Application No. 10/802,385
Amendment Dated October 12, 2006
Reply to Office Action of April 12, 2006

Amendments to the Drawings

Fig. 1

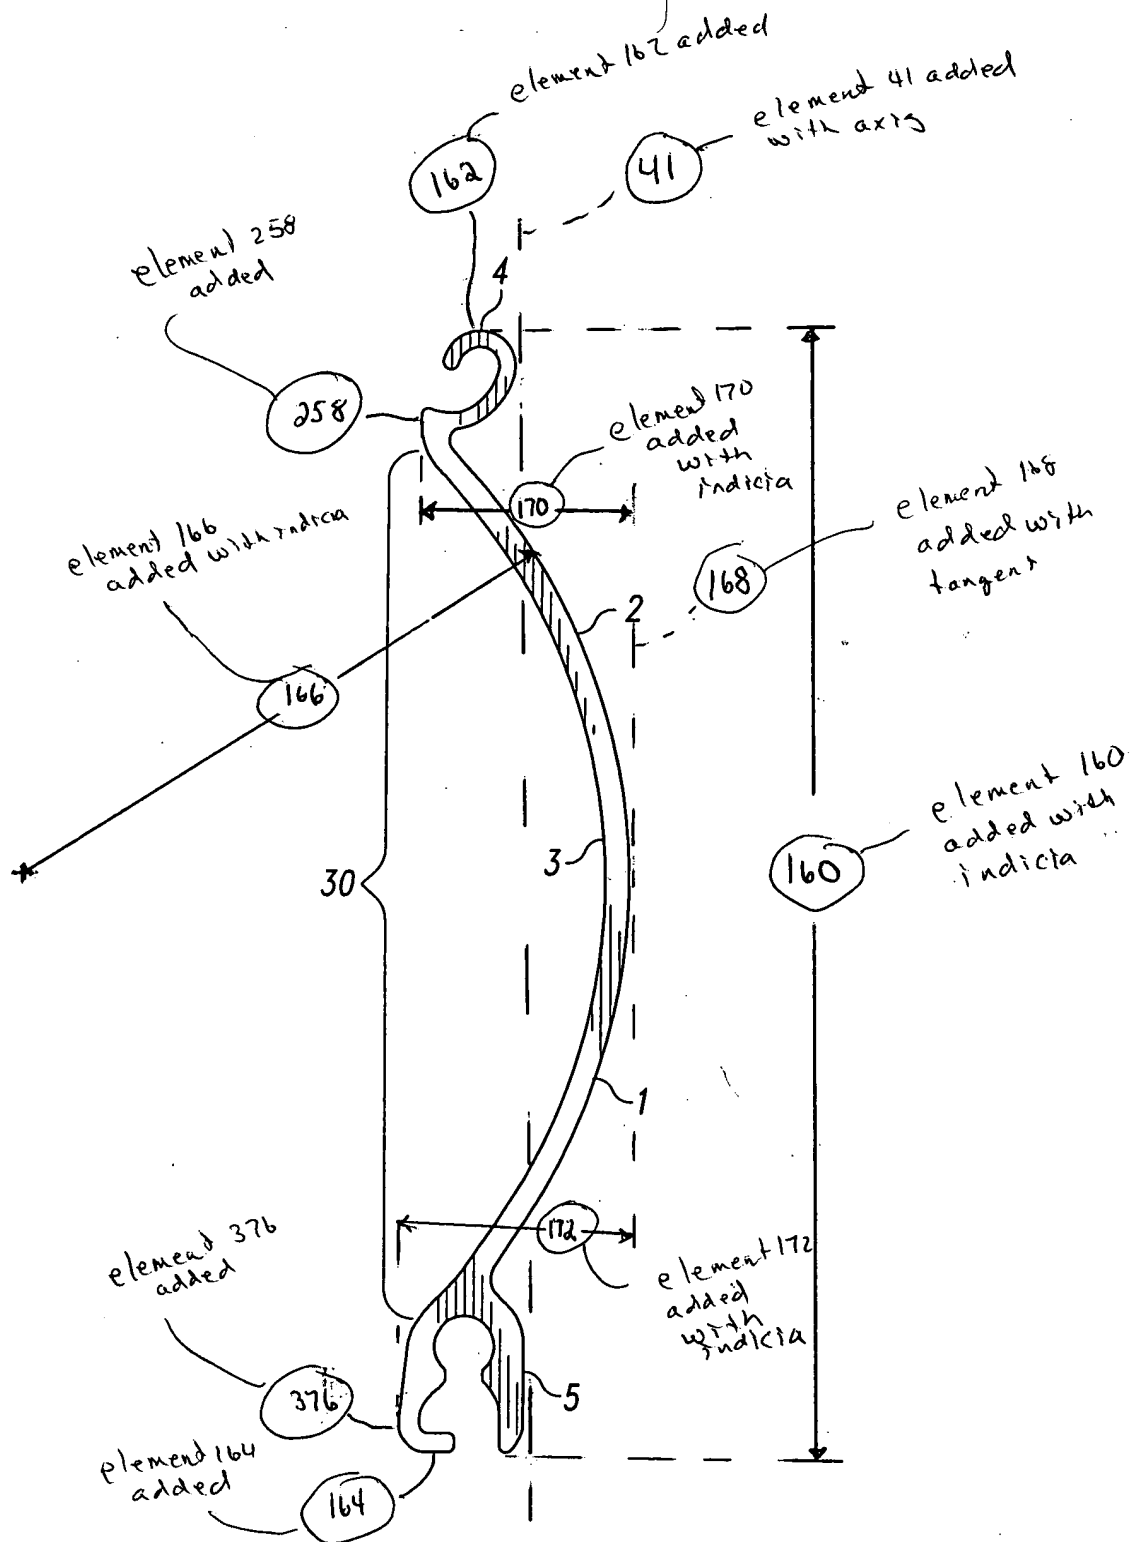
The amendments to the drawings provide reference numerals, lead lines and other indicia to support recitation of the material disclosed in Figs. 1-3 as originally filed in this application.

Fig. 2 placed on separate sheet copied
at higher magnification and reoriented

Fig. 2

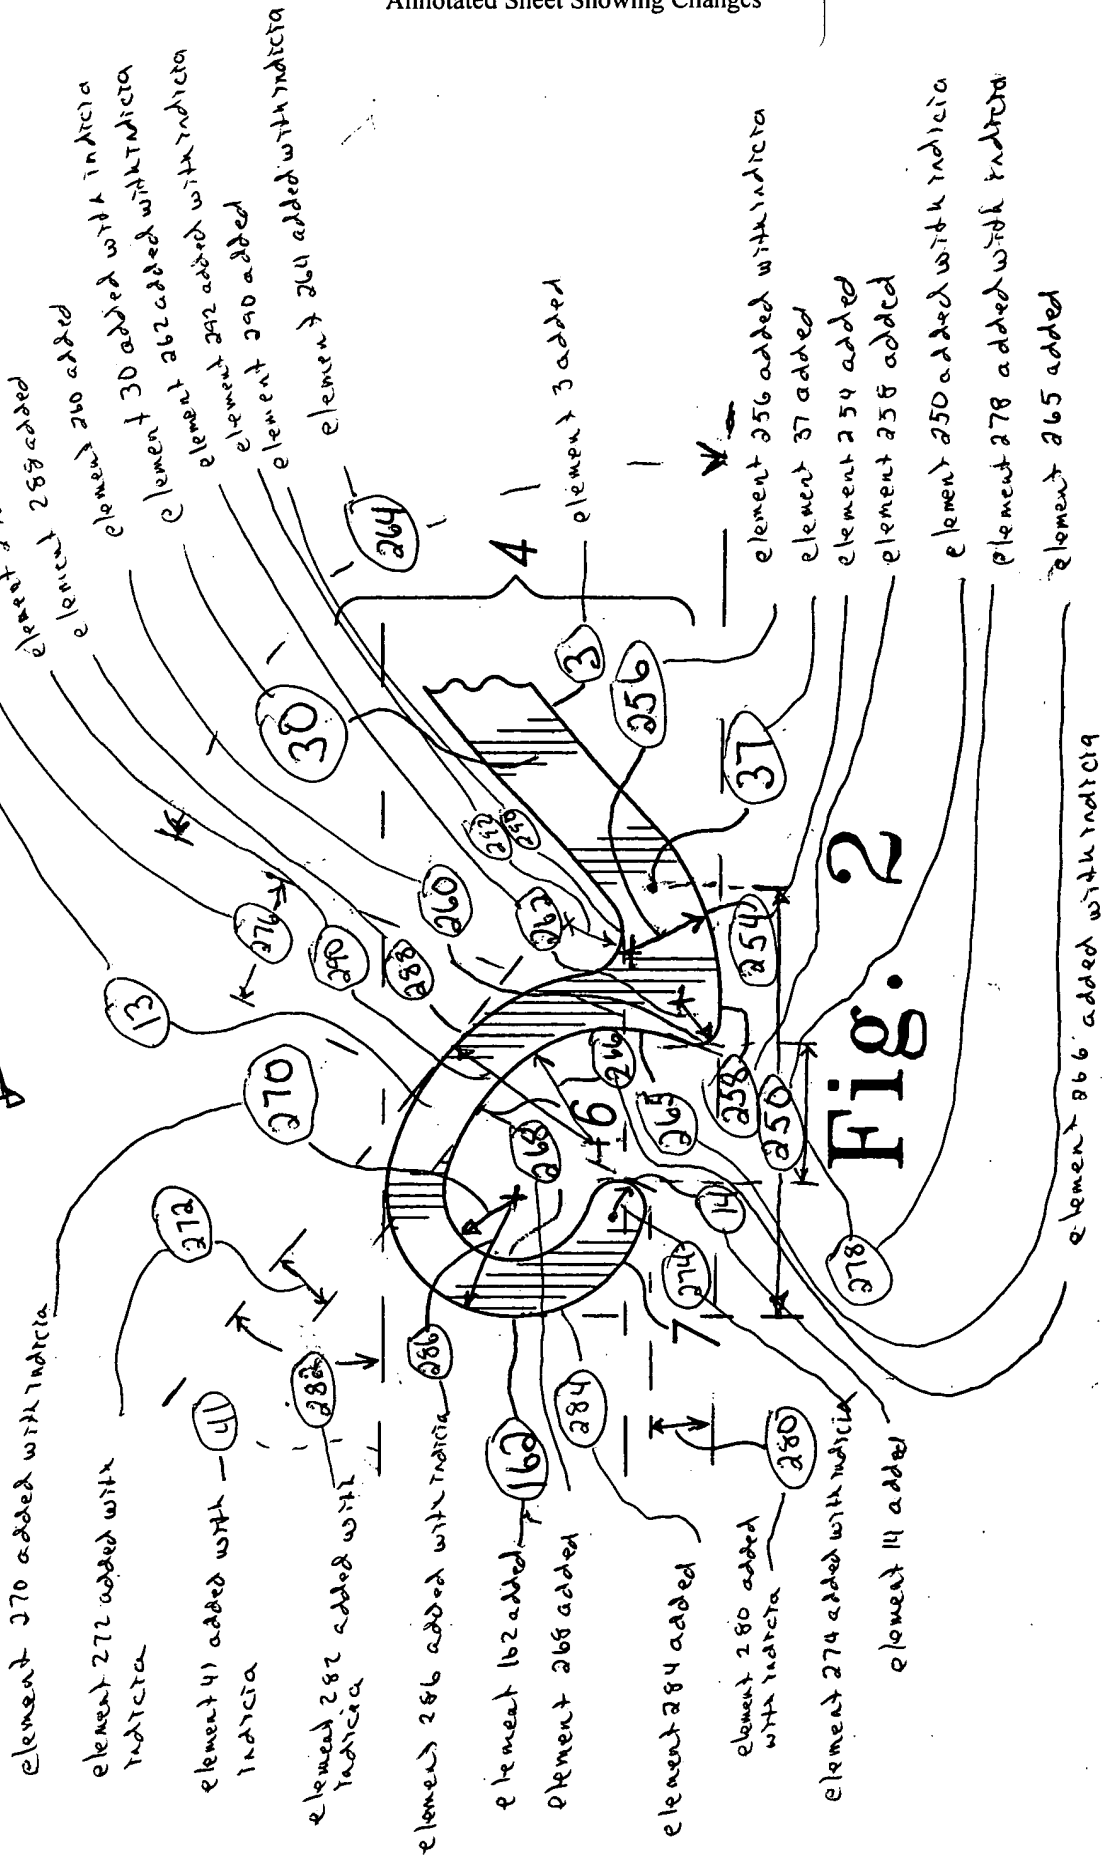
A substitute specification has been submitted which includes an amendment to correct a scrivener's error in the Brief Description of Figs. 2 and 3 to have the Brief Description conform to the Detailed Description that consistently refers to Fig. 2 as showing an engaging track and Fig. 3 as showing a receptacle track and to recite information clearly shown in Figs. 1-3 as originally filed. The annotated specification shows additions as double underlined material and deletions as strikethroughs.
